**Subject: October 2013 Inspection Report
Cameco Resources Permit 603**

OCTOBER 2013 INSPECTION REPORT

PERMIT 603

Figure 2 New piping for underground haulageway restoration wells CIMW-1 and CRMW-3

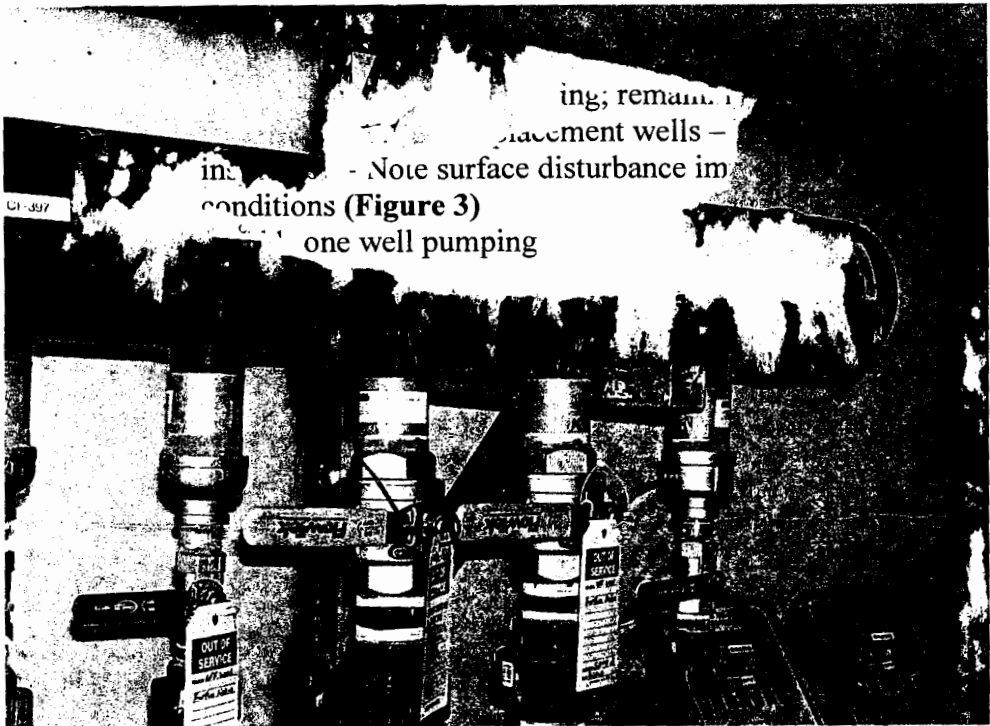
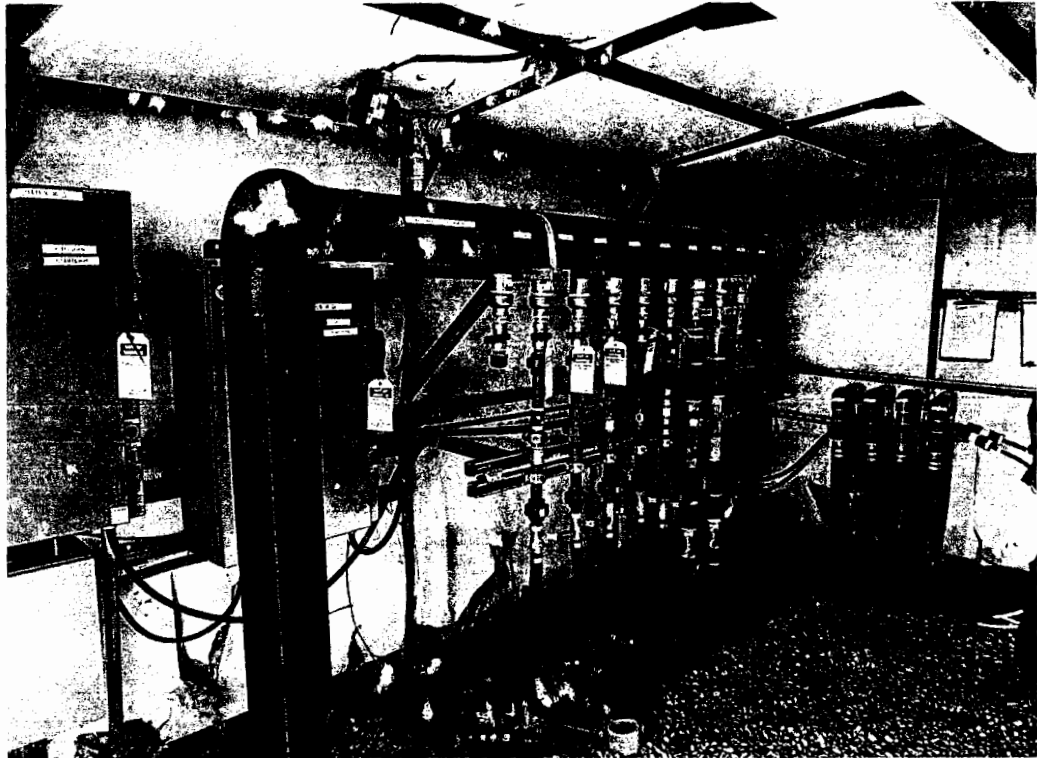
- Inspected HH 12, GWS
 - Inspected HH E12 also used for HHD2-3, DP-22 operating
- MU-C
 - Six wells along the haulageway @ approx. 600' piped to HH C-19 (**Figures 2, 3 & 4**) Request to turn on the wells but need approval for converting the wells (will discuss at meeting with LQD Supervisor on 10-25-14)

1. The wells used for the underground haulageway restoration (CIMW-1, CRMW-2, CRMW-3 and CRMW-4) were noted to be piped into HH -C19 during the inspection. To date, Cameco does not have an approved restoration plan for the haulageway. LQD sent review comments addressing the proposed plan on January 3, 2013. No response has been received. LQD agreed to allow Cameco to pursue restoration of some mine units while restoration plans and reviews are in progress. However, delays in the reviews to approve the restoration plans are not acceptable. Please submit the responses to comments within 30 days.

Figure 6 Road disturbances to topsoil for construction of mud pits in MU-H (replacement wells)

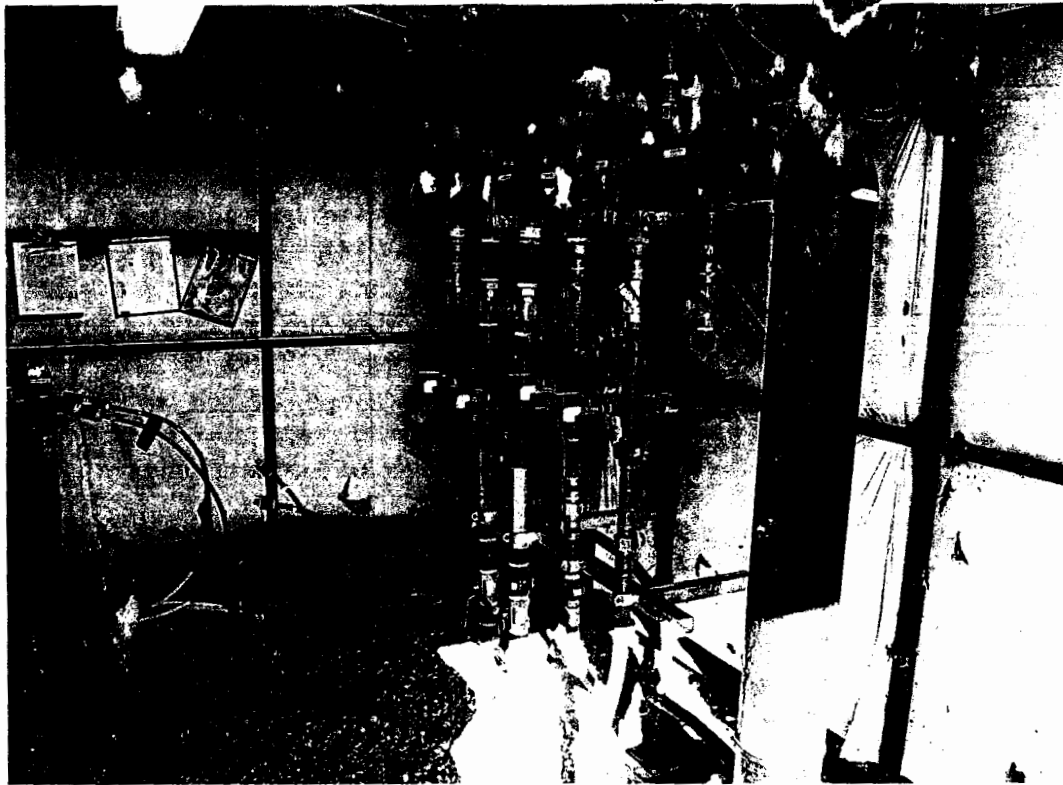
- MU-H
 - Inspected HH 1, Four wells in operation to remove residual uranium
 - HH 4 and HH 14 not operating; remaining HHs are operating
 - Proposal for sixteen replacement wells – Mud pit construction ongoing during inspection – Note surface disturbance impacts due to heavy equipment on wet conditions (**Figure 3**)
 - HH 11, one well pumping
- MU-I
 - Inspected HH 6, twelve wells producing and twelve wells injecting

2. The surface disturbance in MU-H due to mud pit construction was noted. Cameco is reminded as stated in the permit, *Areas where topsoil has not been removed, such as temporary non-routine access to individual well drilling sites, is not intended for routine vehicular access. Regular access across such areas is restricted to foot traffic or low bearing pressure vehicles to prevent topsoil compaction.* Please continue to encourage the field operators to use designated pathways as much as possible to access the construction sites. Please ensure the appropriate reclamation work including chisel plowing or ripping of the soil is completed followed by reseeding the soil.
